# Impact of DFE tap on FFE tap limits in TDECQ penalty computation

Laurent Alloin, Eric Maniloff, Amitkumar Mahadevan  
Ciena

# Evolution of FFE taps with DFE

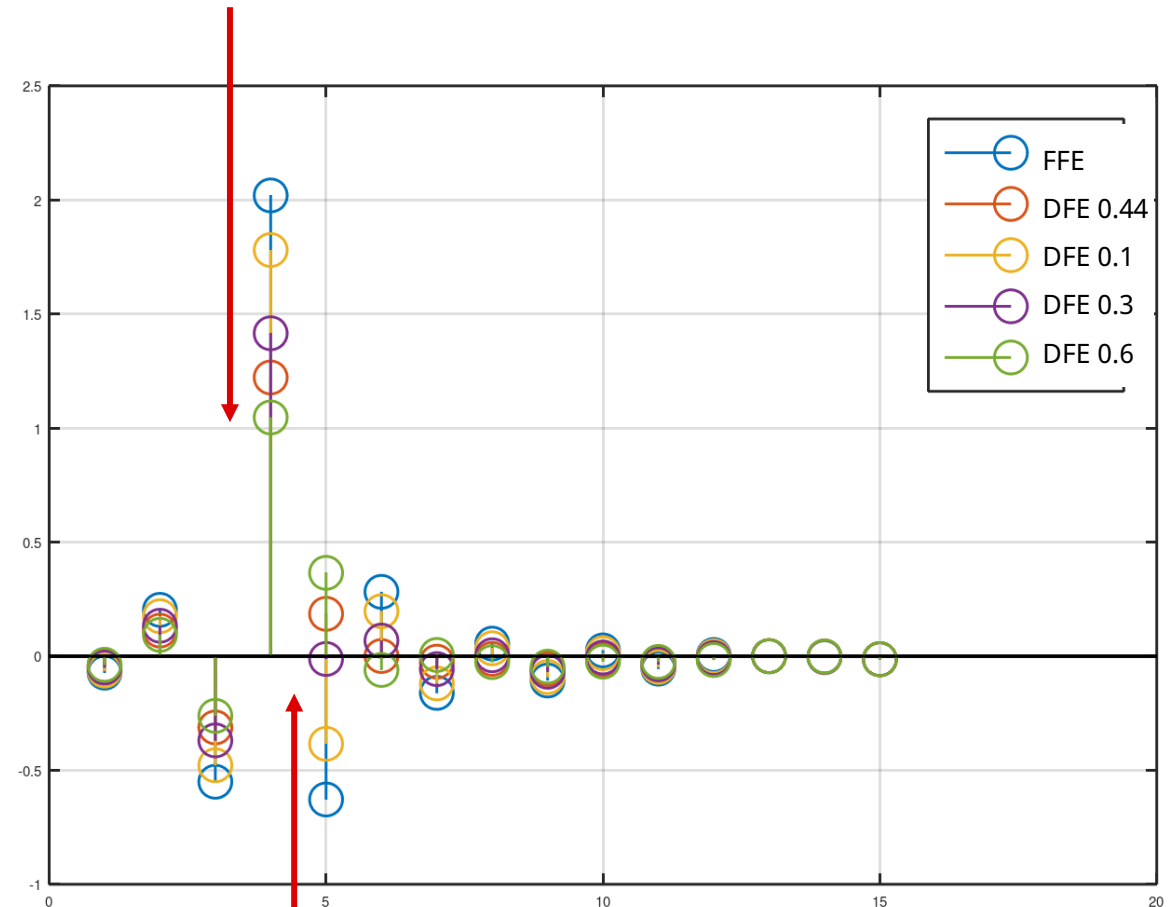
Main tap  $w(\mathbf{0})$  reduces inversely proportionally to DFE tap  $b(\mathbf{1})$  increase

Main tap  $w(\mathbf{0})$  reduces as  $b(\mathbf{1})$  increase

Postcursor  $w(\mathbf{1})$  increases as  $b(\mathbf{1})$  increase
